**Subject** ▶ Changes on Fan110, Fan Housing Complete and Fan Cover

**For Models** ▶ 4014N and 4014NV(Blowers)

This is a revised version of TEC-111/95.

1.Fan 110

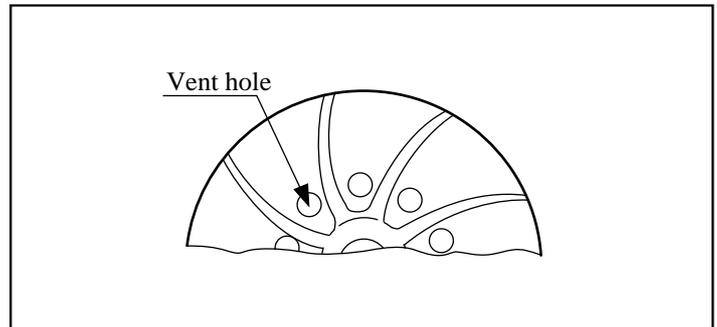
- (1) The vent holes in the fan 110 have been changed in shape as illustrated below.
- (2) Ribs have been added for reinforcement.

As a temporary step, the fan 110 illustrated on the right has been used from May to Oct., 1995.  
Fully changed (new type) fan 110 has been used from Nov., 1995.

2.Fan housing complete and fan cover

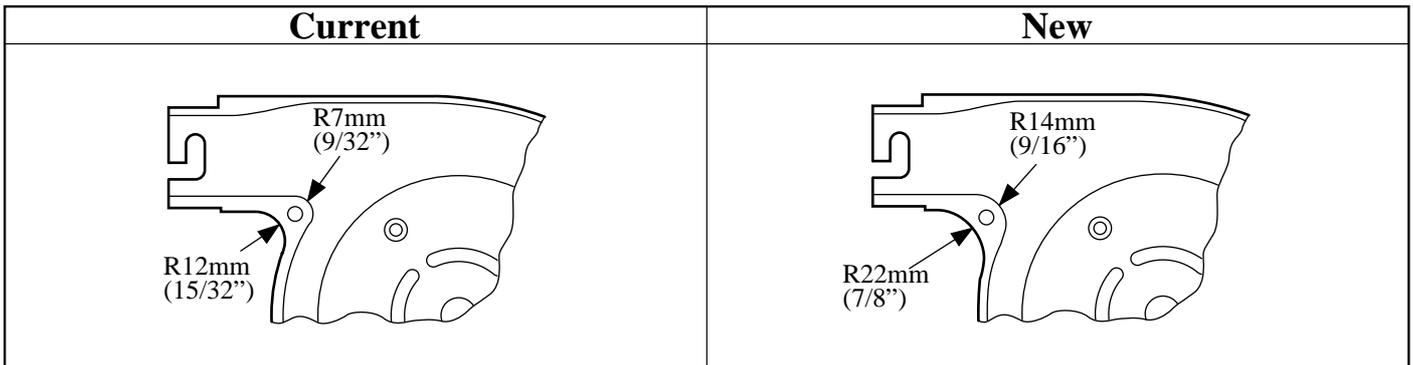
Item No.	Current part	Q'ty	I/C	New part	Q'ty	Note
	Fan 110 241807-7	1	No	Fan 110 241888-1	1	Interchangeable as a set ↑ ↓
	Fan housing complete 157464-0	1	No	Fan housing complete 159855-1	1	
	Fan cover 410482-2	1	No	Fan cover 415921-7	1
